Public Notice of Application for Permit

PUBLIC NOTICE DATE: February 24, 2015
EXPIRATION DATE: March 10, 2015
REFERENCE NUMBER: POA-2014-436
WATERWAY: Zimovia Strait

PUBLIC NOTICE REVISION

Rock Fill Lot 6 BLK A
for Residence buildings
POA-2014-359 Revised
1/5/2015
Zimovia Strait
September 2014
Sheet 1 of 2

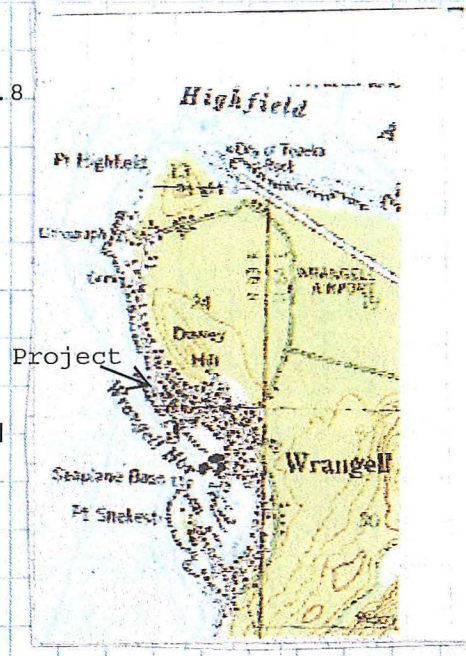
The applicant has submitted revised plans, reducing the volume of shot rock to be discharged below the HTL from 920 cubic yards to 360 cubic yards, and reducing the fill pad from 30 feet by 80 feet (0.06-acre) to 30 feet by 30 feet (0.02-acre). Additional work includes: constructing a 20 feet by 25 feet pile supported deck, a 10 feet by 30 feet pile supported ramp, and a 20 feet by 20 feet pile supported platform. All piles would be 5 inch diameter galvanized steel, and the height of the pile supported structures would be +23 feet (MLLW) to minimize view obstructions.
